Product/Process Change Notice (PCN)

PCN #: PCN_IndLQ_20180206

Product Affected: WE-LQ size 1210 series

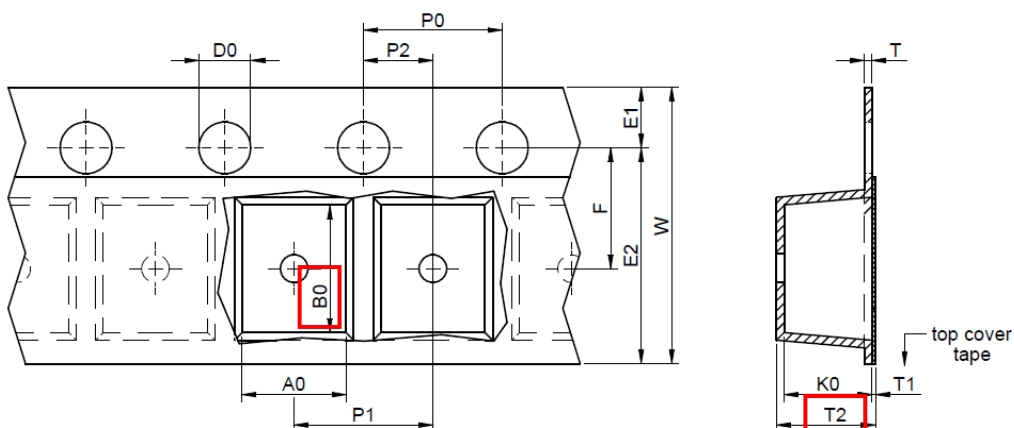
In order to improve the transportation safety, Würth Elektronik will change the cavity of the carrier tape.

The dimensions B0 and T2 will be changed from 3.70 mm and 3.50 mm, respectively, to 3.35 mm and 2.50 mm, reducing the cavity size for a better fitting of the parts in to the carrier tape.

Dimension	Before Change	After Change
B0	3.70	3.35
T2	3.00	2.50
